Ducted Systems Technical Services: YS Letter

Letter: YSR-001-25

Subject: **JHET, JMET, JME, JHE & JSE Standard ECM Blower Motor Speed – Undesired Operation (YSR-004-24, 9/19/2024 Updated)**

Product: JHET, JMET, JME, JHE & JSE (JME, JHE & JSE added)

ECM Sub Board

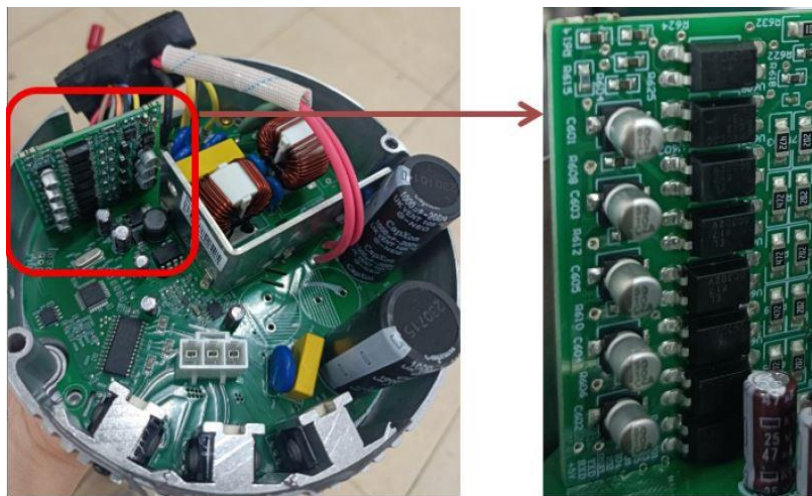
DM3 motors have a sub-board inside the module. The purpose of the sub-board is to enable nine tap speed operation for the R454B standard ECM AHU models.

During our investigation along with the motor manufacturer it has determined some sub-boards may have been damaged during motor programming that can create a path to ground through the heat kit blower speed conductor if a heat kit installed. An example is if the heat kit blower speed conductor is on speed tap 5 and not energized but a lower blower speed such as tap 3, the blower runs on the higher speed tap. The path to ground is through the heat kit relay/contactor windings back to the common on the motor.

S1-03103899000

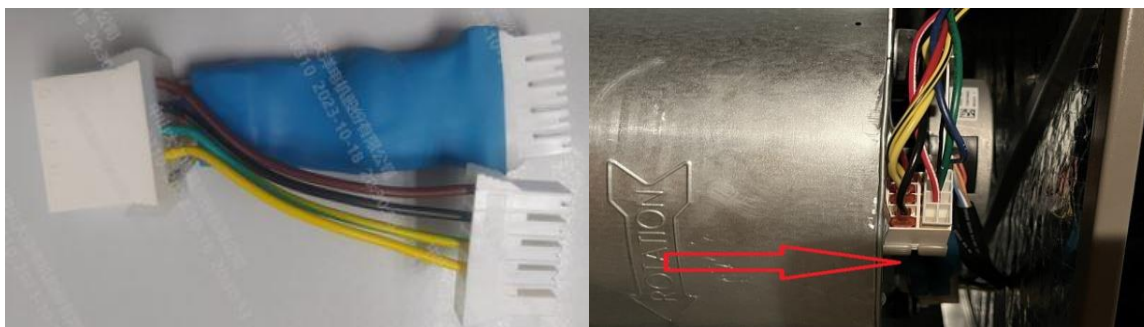
- Ensure a lower speed taps energized, and the motor is running at a higher speed (confirmed via amperage), simply disconnect the wire connected to the higher blower speed tap to see if the motor slows down.

Once confirmed the field repair is adding S1-03103899000 BOARD, CIRCUIT, EXTERNAL CONVERSION in series with the LINE and LOW voltage going to the motor by simply disconnecting AHU wires to the motor, connecting the harness to motor, and connecting AHU wires to the harness.

Field installed S1-03103899000
